**Rowan County, North Carolina**  
**Telecommunications Site Review**  
**New Telecommunications Facility**

August 30, 2022

**RE: APPLICANT/PROVIDER:** Amazon Kuiper Infrastructure, LLC  
**SITE ID:** CLT501 / Mt. Ulla  
**ADDRESS:** 0 Upright Road, Mount Ulla, NC 28125  
**LATITUDE:** 35° 38' 58.2" N **LONGITUDE:** 80°40' 05.3" W

**Figure 2 – Proposed Ground Compound**

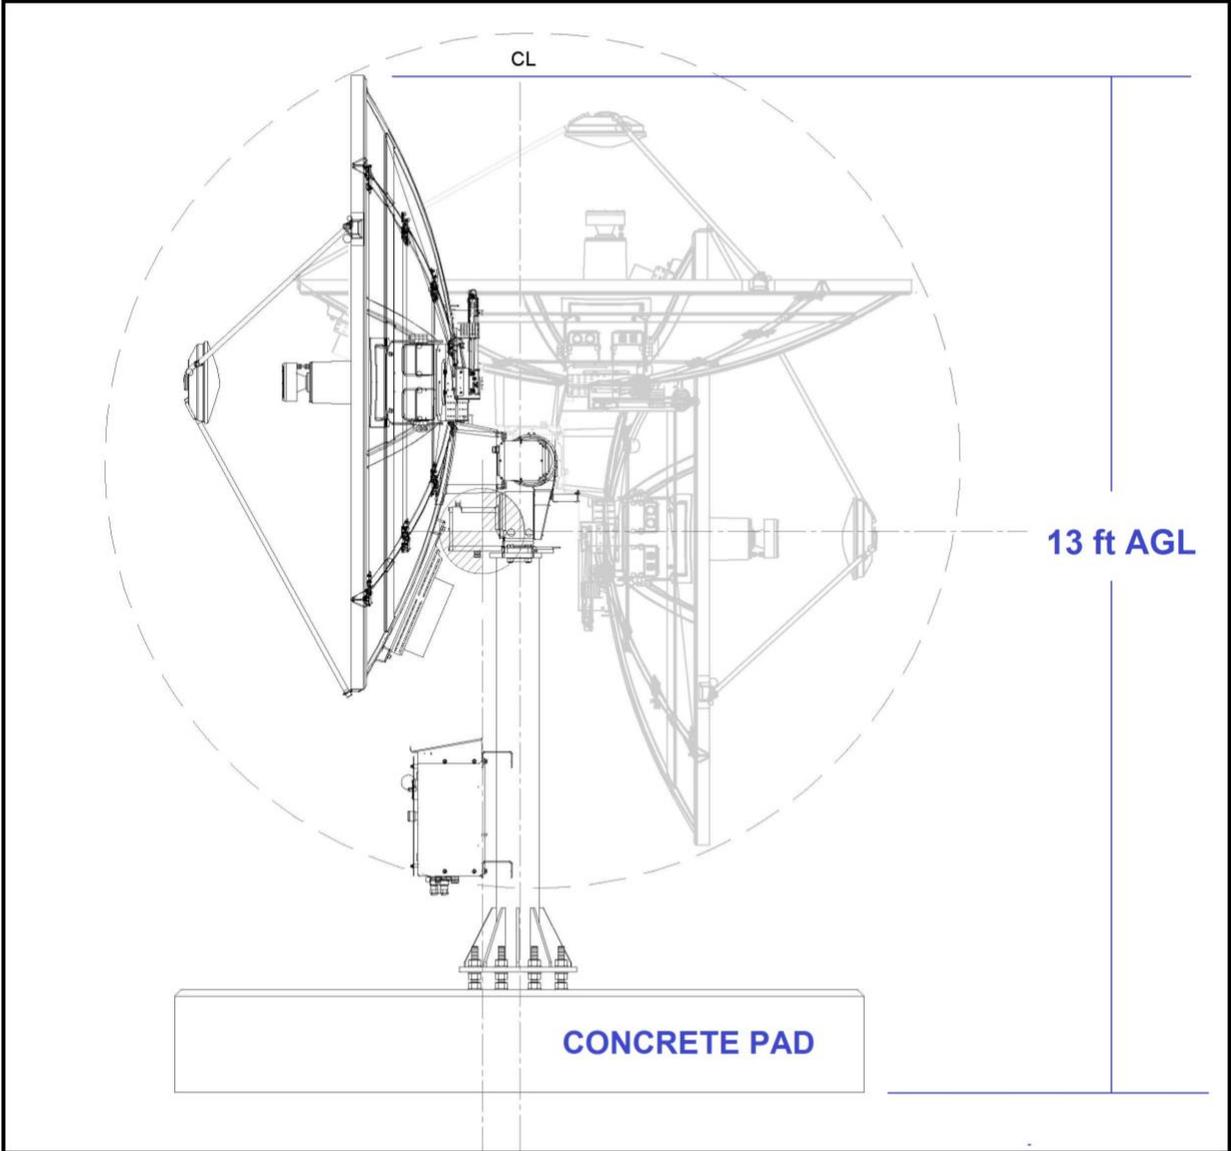
The Applicant proposes to install a ten (10) foot high non-perforated corrugated metal fence around the facility compound for security purposes and to provide a buffer against interference to other communications facilities operating on the same frequencies in the area. The Applicant also proposes to plant Judd Viburnum shrubs around the compound fence on the north, east and south sides (at least four feet tall at time of planting).

The site plan shows a twenty-three (23) foot setback between the center of each dish concrete pad and the compound fence, equal to the maximum dish height of thirteen (13) feet including the pier, plus ten (10) feet in accordance with Section 21-60(4)(c) of the County Ordinance.

1. Prior to permitting, Applicant shall provide a structural analysis report by a registered North Carolina structural engineer certifying that the satellite dishes will comply with ANSI/TIA-222 G or H standards and the 23-foot fall radius; and,
2. If an emergency power backup generator is to be used, its noise level shall not exceed 65dBA at the nearest property edge. Testing shall be limited to the hours between 9:00 A.M. and 4:00 P.M., (Monday through Friday); and,
3. Clearly visible signs warning of potential RF exposure risk shall be affixed to the compound fence in accordance with FCC Rules and Regulations and OET Bulletin 65; and,
4. No advertising shall be posted on the compound fence.
